## Advanced Auto Parts JSP12-74

Consideration of the request of WXZ Development, for Preliminary Site Plan and Stormwater Management Plan approval. The subject property is located in Section 23 at 42520 Grand River Avenue, north of Grand River Avenue and east of Town Center Drive in the B-3, General Business District. The subject property is 1.6 acres and the applicant is proposing a 6,895 sq. ft. Advance Auto Parts retail store.

# PLAN REVIEW CENTER REPORT

**SUBJECT: Advance Auto Parts, JSP12-0074,  
Traffic Review of Preliminary Site Plan (PSP12-0055)**

Figure 1. Site of Proposed Advance Auto Parts

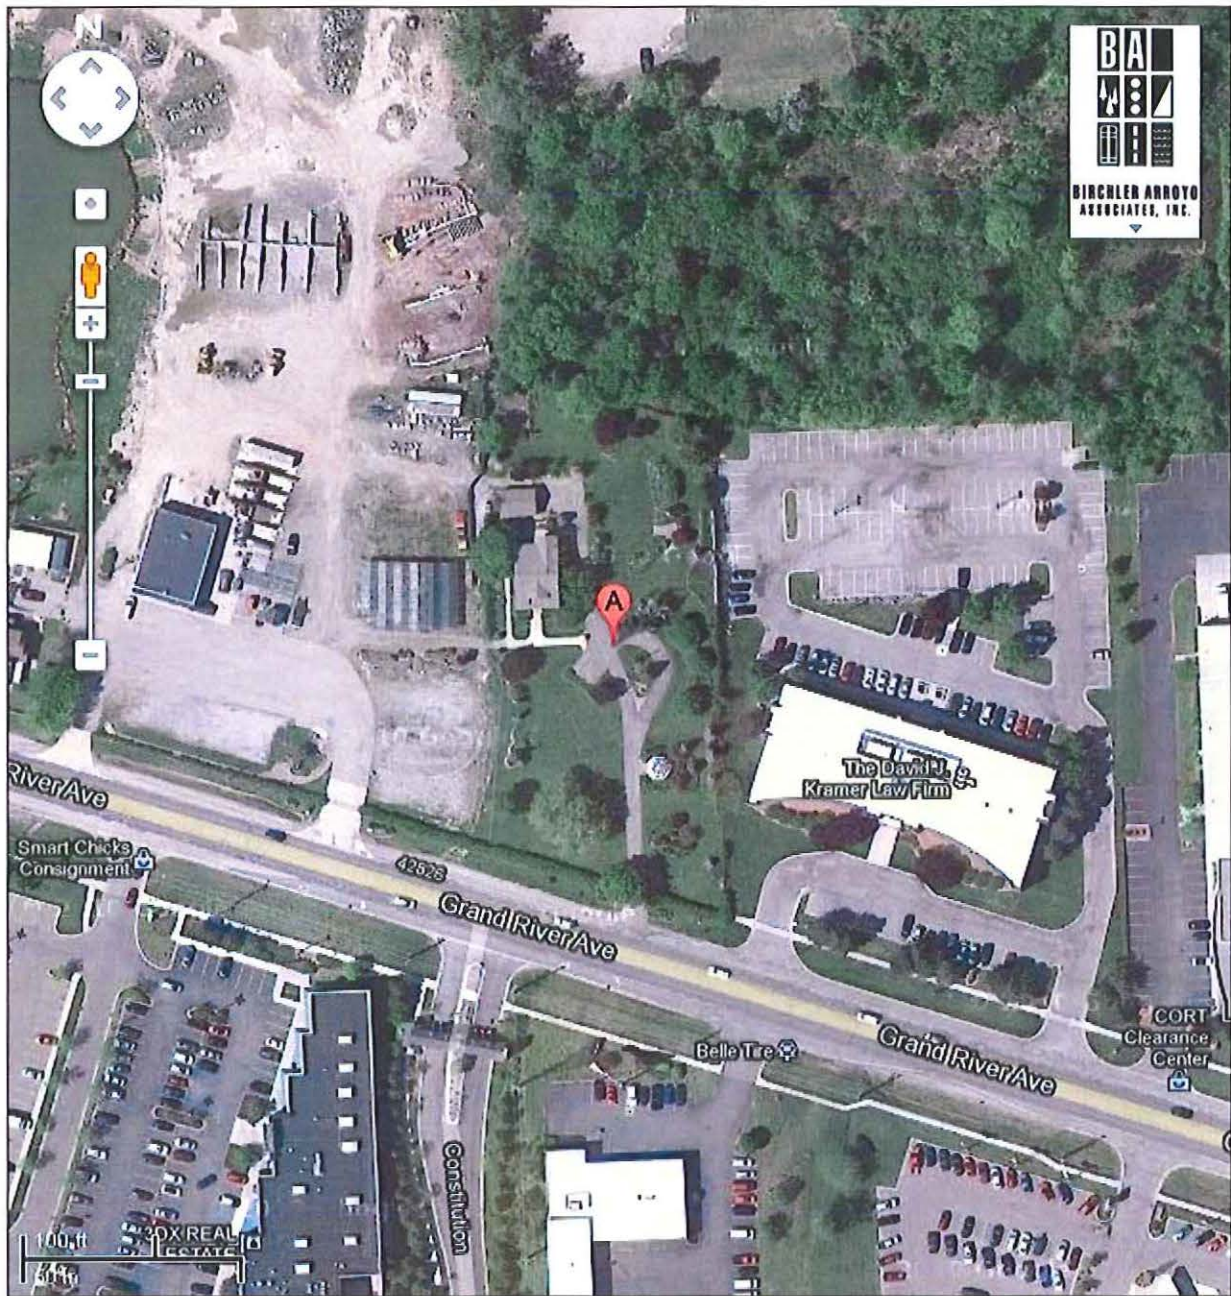
1. The applicant, WXZ Development, Inc., is proposing to construct a 6,895-s.f. auto parts store at 42520 Grand River (Figure 1). The lot is only 160 ft wide and the sole proposed means of vehicular access is a driveway offset slightly east of Constitution Drive (Figure 2).

Figure 2. Area Served by Constitution Drive

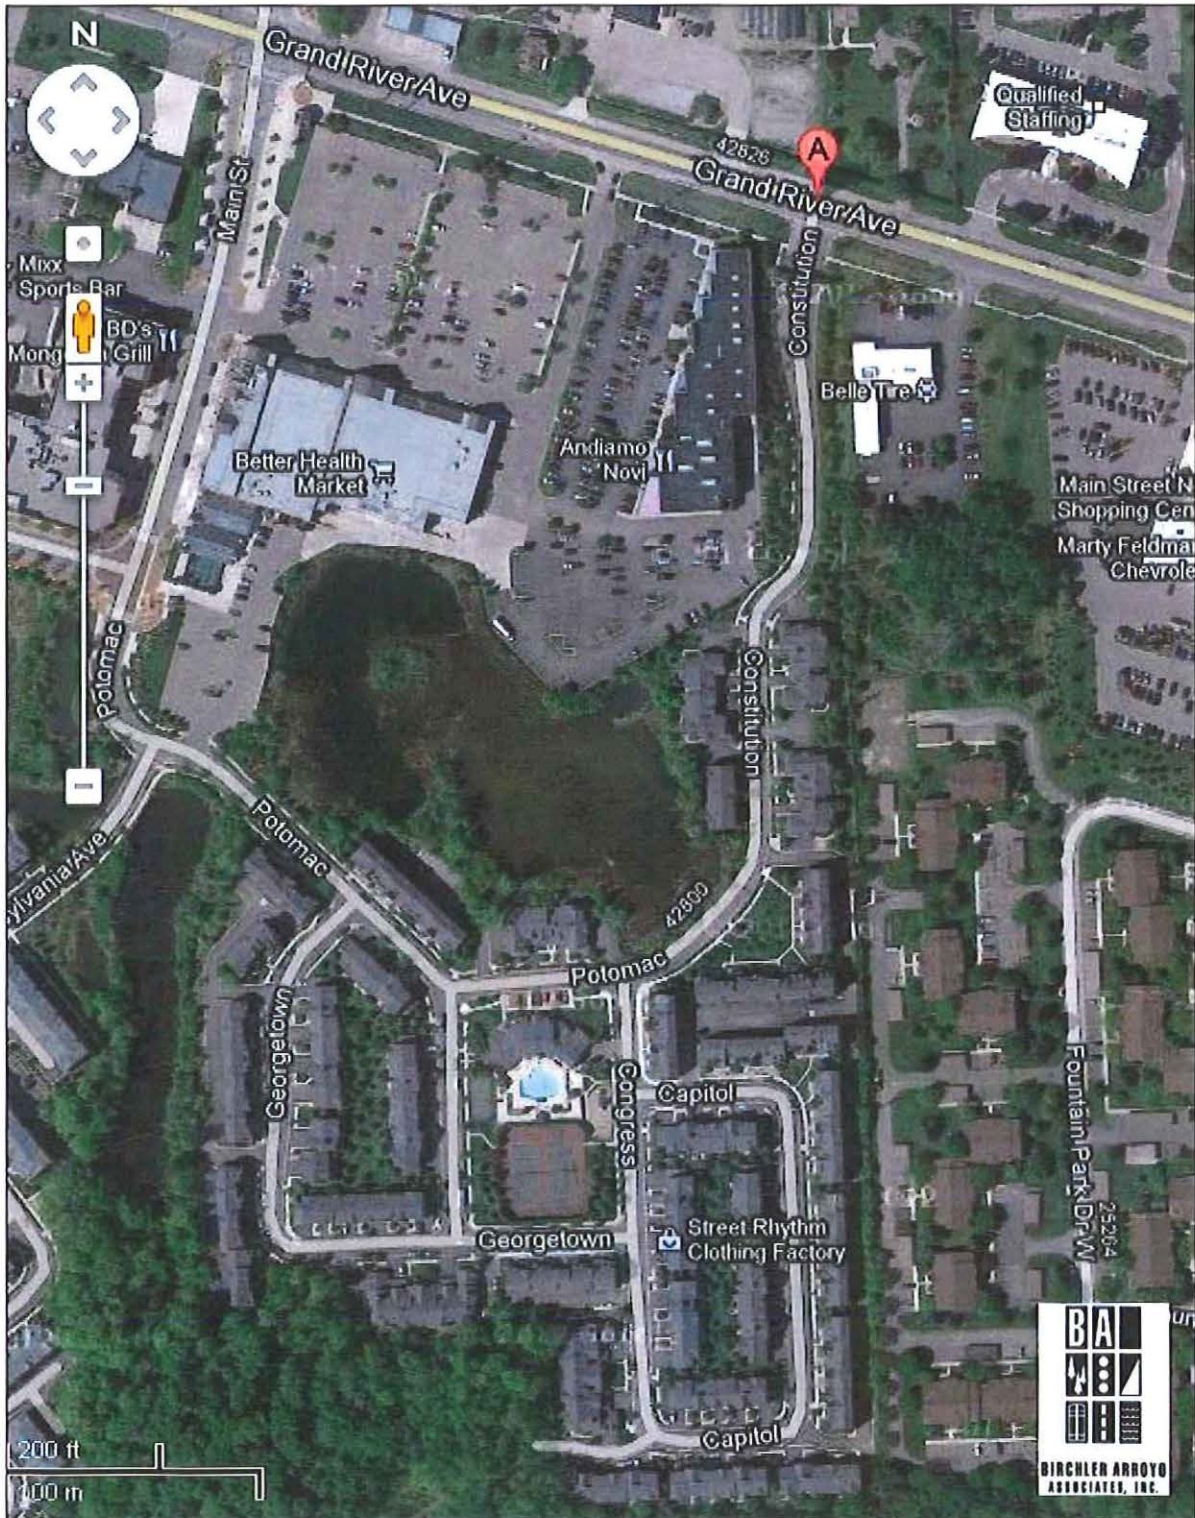
4. Given the two-way left-turn lane on Grand River, the proposed driveway location relative to Constitution Drive is even more problematic. The effective centerline of Constitution relative to entering left turns is the west edge of the median island. The physical centerline of the new driveway would be offset 42 ft to the east of that reference point, creating a very awkward "interlock" between would-be left-turn vehicles traveling in opposite directions in Grand River's center lane. Based on the large area served by Constitution (Figure 2), we would expect the westbound left-turn volume attempting to enter that street would be fairly substantial, especially in the PM peak hour when opposite-direction left turns into the proposed store would also be at or near their peak. DCS Fig IX.12, referenced in Sec 11-216(d)(1)e, requires a minimum opposite-direction spacing for this direction of offset of 200 ft; hence, **a Planning Commission waiver of DCS Sec 11-216(d)(1)e would also be required.**

**Alternative A: Flat Parking Surface with Sidewalk Ramped - Wheel Stops Not Required**

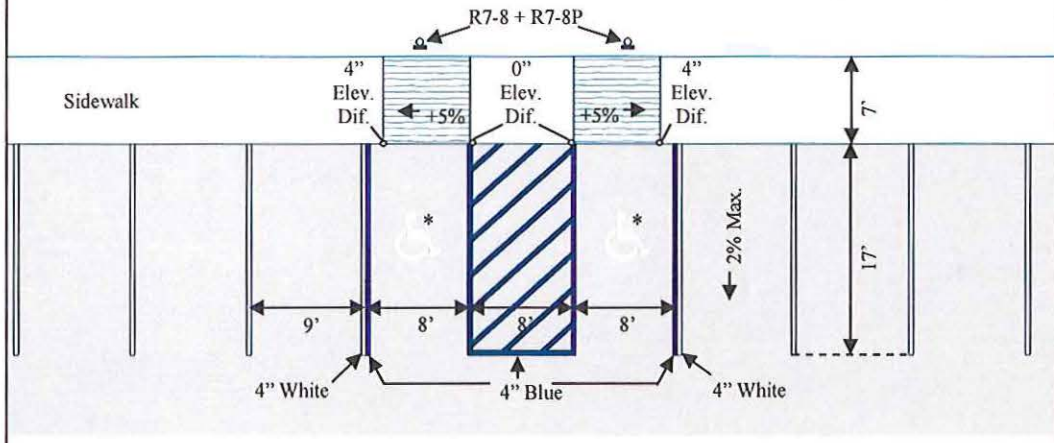
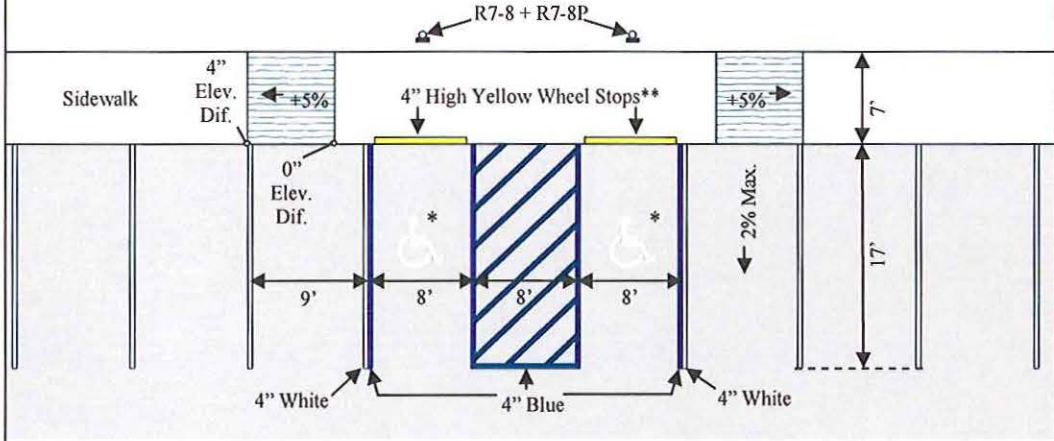
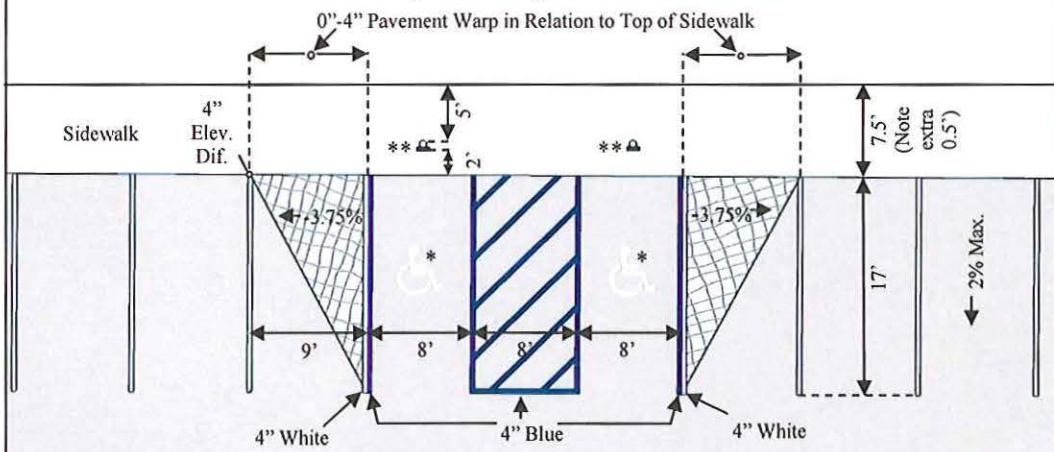
11. **We are unable to find the cited "ADA ramp detail" for the sidewalk location served by the barrier-free access aisle.** Attached to this letter are three common alternatives for providing the required ramp. We have a general preference for Alternative A, since it does not require bumper blocks or a warping of the pavement surface (which complicates maintenance and could pose a tripping hazard).

ADA Details will be added to the plan.
